[Docket No. FAA–2025–0011; Project Identifier AD–2024–00618–R; Amendment 39–23053; AD 2025–11–07]

Airworthiness Directives; Robinson Helicopter Company Helicopters

ACTION: Final rule.

SUMMARY: The FAA is superseding Airworthiness Directive (AD) 2024–19–11 for all Robinson Helicopter Company Model R44 and R44 II helicopters. AD 2024–19–11 required visually inspecting a certain flex plate assembly (flex plate) and certain clutch shaft forward yokes (yokes), including each flex plate bolt, and depending on the results, taking corrective actions. AD 2024–19–11 also required removing certain yokes from service within a specified threshold, or as an alternative, performing in-depth inspections. Since the FAA issued AD 2024–19–11, it has been determined that clarifications regarding the alternative inspections are necessary. This AD requires the actions of AD 2024–19–11 and clarifies that the alternative inspections are repetitive and adds a particular paint remover option to use when performing those alternative inspections. The FAA is issuing this AD to address the unsafe condition on these products.

Figure 1 to Paragraph (g)(1)(i) - Flex Plate Inspection

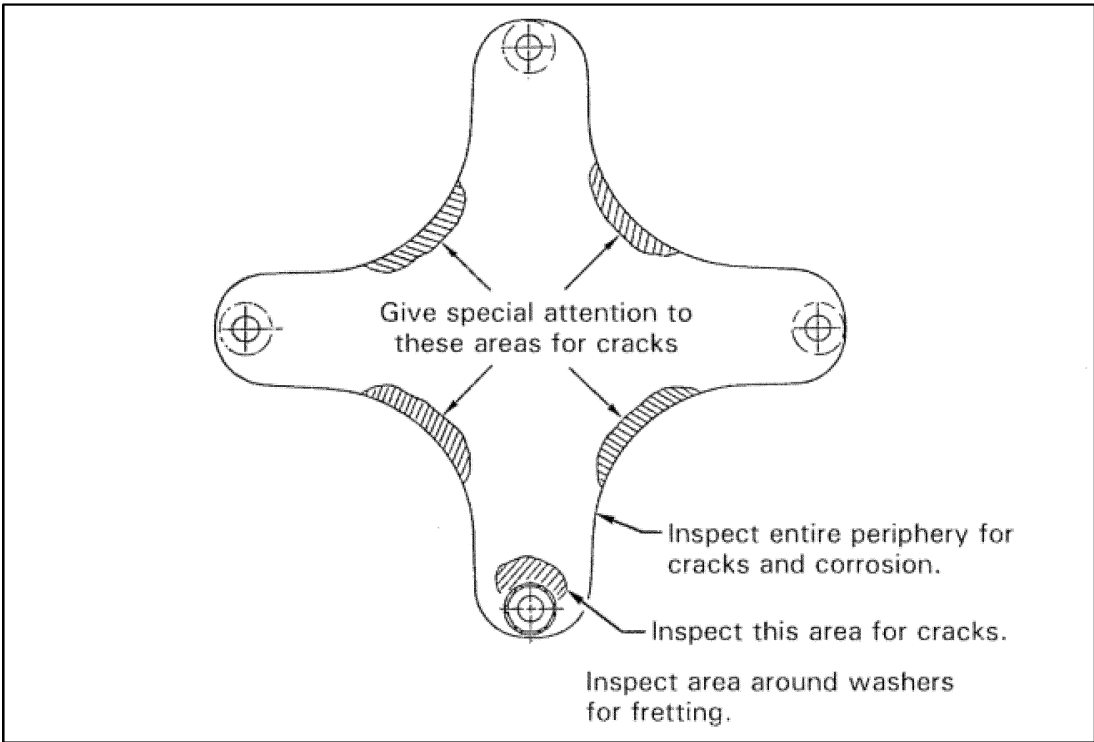
(i) Visually inspect forward flex plate assembly part number (P/N) C947–1 (flex plate) for any loose fasteners, cracks, fretting, corrosion, wear, and to ensure that the washers are bonded to both sides of each flex plate arm, in the areas depicted in Figure 1 to paragraph (g)(1)(i) of this AD. If there is any loose fastener (can be moved by hand), crack, fretting, corrosion, or wear that consists of the washers not securely bonded to both sides of each flex plate arm, before further flight, remove the flex plate from service and replace it with an airworthy flex plate.
